Pakenham East PSP 1210

Victorian Planning Authority

Traffic and Transport: Expert Witness Statement

May 28, 2018

Figure 1: Trip Generation Calculations (yellow numbers indicate volumes after internal trip reduction)

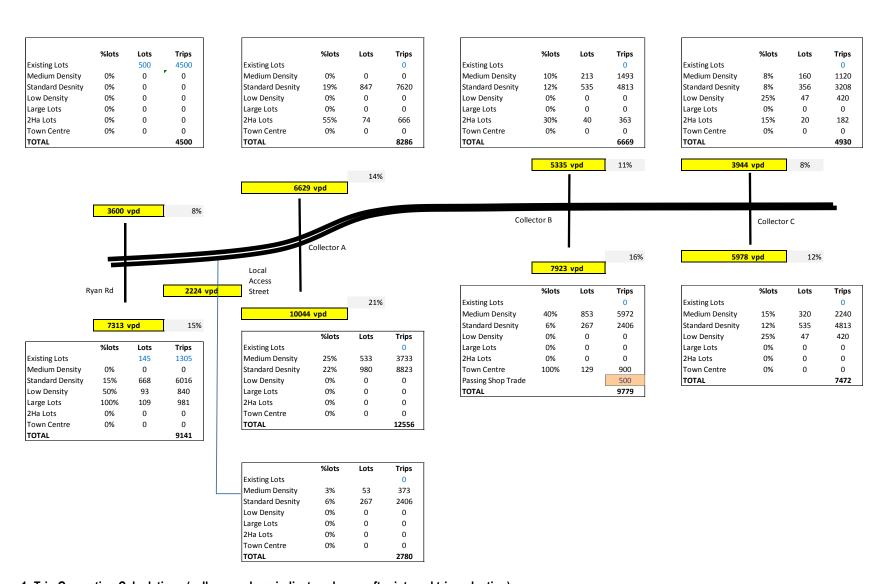
Based on a lot yield plan presented in the exhibited Draft PSP, the anticipated number of daily trips generated at full build has been calculated as shown in Figure 1, these are based on the following trip generation rates (per lot) and assumptions:

- Standard density: 9 trips per day / 0.9 trips per peak hour
- Low density: 9 trips per day / 0.9 trips per peak hour
- Large lots: 9 trips per day / 0.9 trips per peak hour
- 2Ha lots: 9 trips per day / 0.9 trips per peak hour
- Town center residential: 7 trips per day / 0.7 trips per peak hour
- Medium density: 7 trips per day / 0.7 trips per peak hour
- Passing shop trade: 500 trips per day / 50 trips per peak hour
- Assumed development north of Ryan Road / Princes Highway intersection: 500 medium density lots

20% discount for local trips

IN-01: Princes Highway / Ryan Road – T-Junction

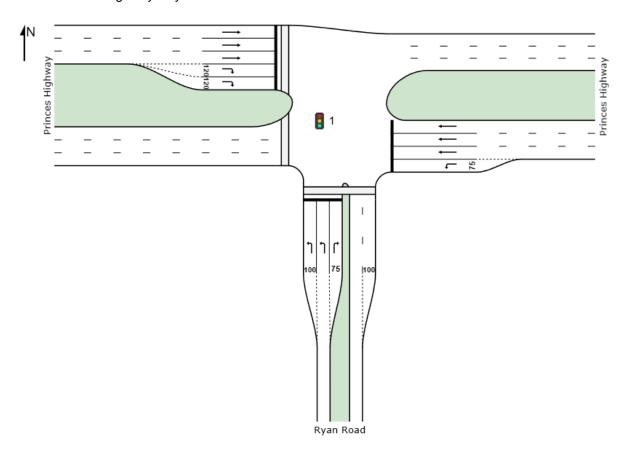
Princes Highway/ Ryan Road - operating as T-intersection

Modifications of the lane configuration of the south approach

- Left turn slip lane converted to an exclusive left turn lane (100m)
- Through and right lane converted to an exclusive left turn lane
- Right turn lane extended to 75m

- 7. If the land to the north of IN-01 is not developed, a T-intersection design with double left turns out of Ryan Road, and double right turns into Ryan Road can be implemented as well as including the pedestrian crossing on the western side of the intersection.

IN-01: Princes Highway / Ryan Road – with double left turns from Ryan Road

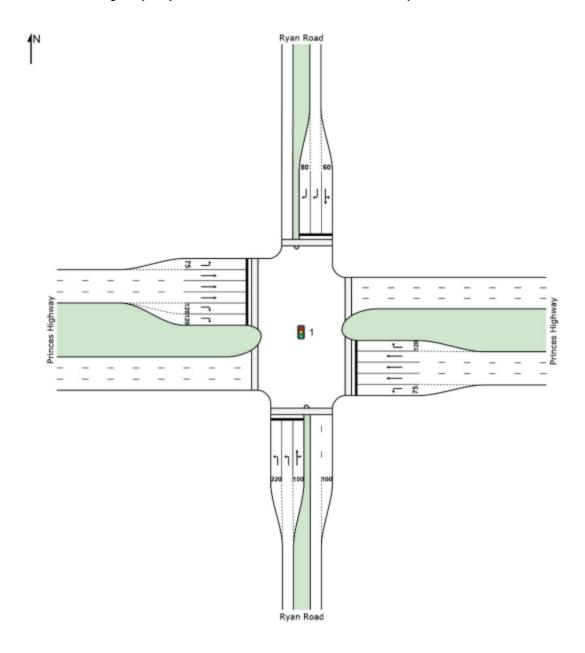
Princes Highway/ Ryan Road - operating as cross intersection

Modifications of the lane configuration at this intersection include:

- Double left turn from the south approach
- Double right turn lanes from the north approach

A left turn slip lane from the south approach is not preferred given the likely impact on the Childcare Centre on the South-West corner and impacts on pedestrians and cyclists. Instead double left turns from the south are included and all pedestrian crossings retained. This results in an intersection degree of saturation marginally above 0.95 (absolute maximum). Given the number of assumptions made in estimating future trip generation and distribution this is an acceptable outcome.

- 5. Alterations are required for the south approach at Ryan Road (IN-01) to cater for the increased traffic volumes since the intersection layouts were prepared for the exhibited draft PSP. In order to retain all pedestrian crossings and avoid the addition of a left hand slip lane, double left hand turns are required. The intersection marginally exceeds the preferred threshold degree of saturation, but given the uncertainty in modelling the ultimate traffic generation and distribution this is an acceptable outcome.

IN-02: Princes Highway / Collector A

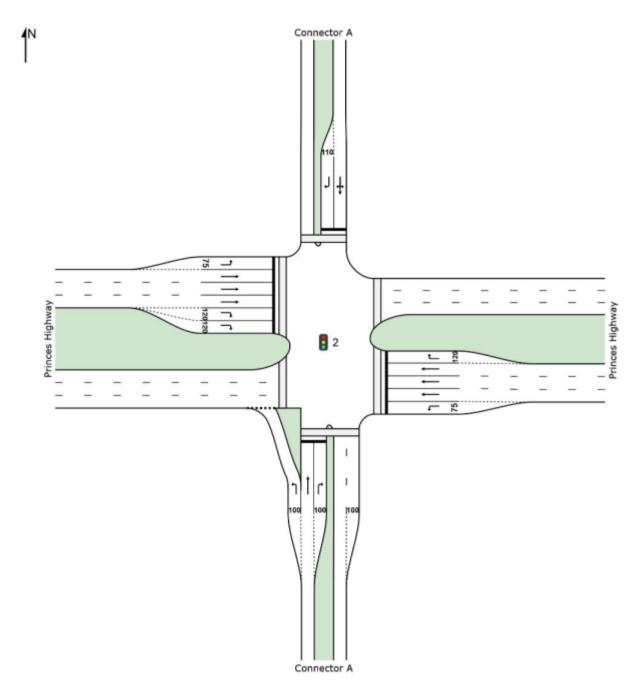
Princes Highway/ Collector Road A

Modification of the lane configuration on the north and south approaches

Right turn lanes increased to 100m for the south approach and 110m for the north approach

Due to the high volumes of left turners in peak hour, a left turn slip lane is proposed on the south approach to reduce the level of service for entire intersection. This is in line with the intersection layout proposed in the exhibited PSP.

IN-03: Princes Highway / Collector B

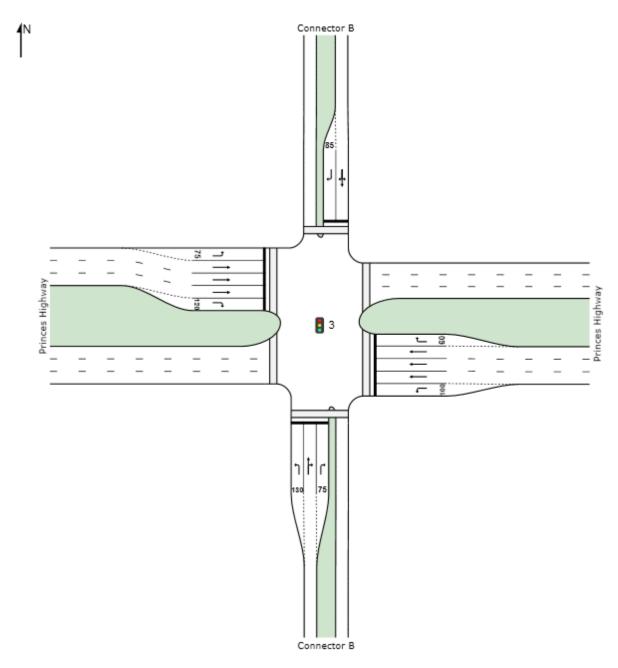
Princes Highway/ Collector Road B

Modifications of the lane configuration on the south approach

- Left turn slip lane converted to an exclusive left turn lane (130m)
- Right turn lane extended to 75m

Modifications of the lane configuration on the north approach

• Exclusive right turn lane extended to 85m
